Access Compliance Report Public Rights-of-Way (Curb Ramps)

Intersection ID: 52523	Main Street: IVEY_DR	Cross Street: LORNA_ST	Location: E
ADA ID: 61E194009634	Ramp Type: Perp	Initial Pass/Fail: Fail	Overall Compliance: No Severity Score: 8.75

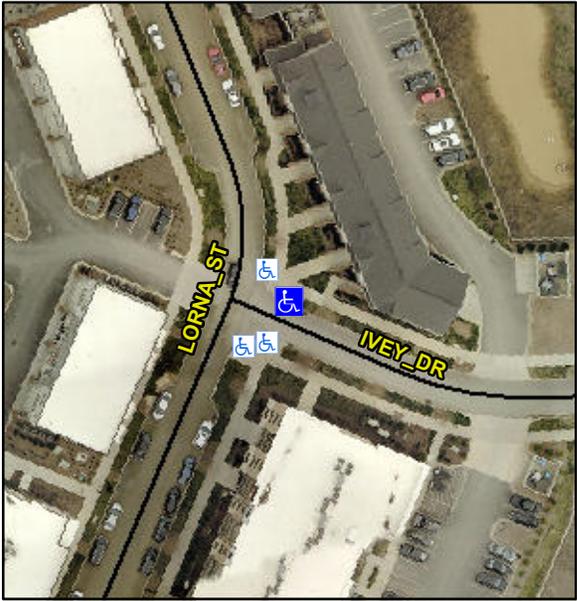
Compliance	Description	Data	Compliance	Description	Data
N/A	Ramp Length (in)	72.0	Yes	Ramp Slope (%)	7.4
No	Ramp Width (in)	47.0	Yes	Ramp XSlope (%)	1.8
N/A	Flare Type LT	N/A	N/A	Flare Type RT	N/A
N/A	Flare Slope LT (%)	N/A	N/A	Flare Slope RT (%)	N/A
N/A	Flare Traversable LT?	N/A	N/A	Flare Traversable RT?	N/A
N/A	Landing Length (in)	N/A	N/A	DWS Provided?	N/A
N/A	Landing Width (in)	N/A	N/A	DWS Contrast?	N/A
N/A	Landing Slope (%)	N/A	N/A	DWS Length (in)	N/A
N/A	Landing X Slope (%)	N/A	N/A	DWS Full Width?	N/A
N/A	Landing Curb? (Y/N)	N/A	N/A	DWS Offset (in)	N/A
N/A	Shared Landing?	N/A			
N/A	Gutter Ponding?	N/A	N/A	Gutter Slope (%)	N/A
N/A	Gutter Lip Ht (in)	N/A	N/A	Gutter X Slope (%)	N/A
N/A	Painted X Walk1?	No	N/A	Painted X Walk2?	N/A
	X Walk 1 Direction	To S		X Walk 2 Direction	N/A
N/A	X Walk 1 Width (in)	N/A	N/A	X Walk 2 Width (in)	N/A
	X Walk 1 Slope (%)	2.9		X Walk 2 Slope (%)	N/A
	X Walk 1 X Slope (%)	3.2		X Walk 2 X Slope (%)	N/A

N/A	Ramp inside XWalk1?	N/A	N/A	Ramp inside XWalk2?	N/A
	Road Slope (%)	0.2	N/A	Clear Space?	N/A
	Road X Slope (%)	1.9	N/A	Clear Space to XWalk (in)	N/A
N/A	Any Obstructions?	N/A	N/A	Storm Grate/Utility Hazard?	N/A
	Obstruction Type			Storm Grate/Utility Type	
			N/A		N/A
			Yes	Surface Condition? (G/P)	Good

Possible Solutions:
Remove & Replace Entire Ramp.
